UNITED STATES PATENT AND TRADEMARK OFFICE
CERTIFICATE OF CORRECTION

PATENT NO. : 6,904,292 B2
DATED : June 7, 2005
INVENTOR(S) : Ozluturk et al.

FIG. 2
PRIOR ART

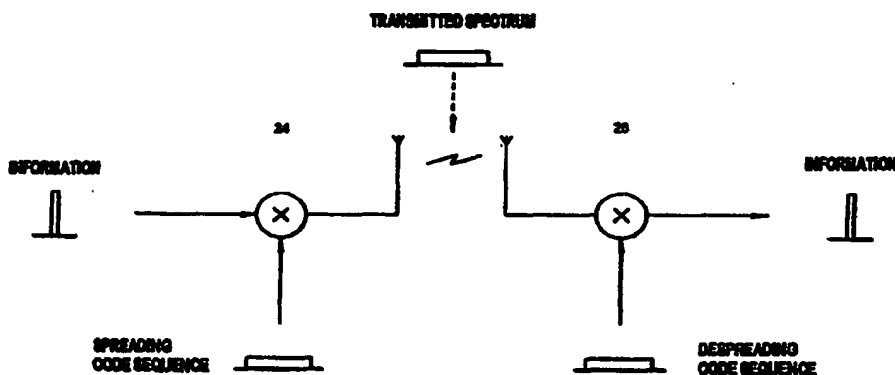
Figure 2, replace with the following:
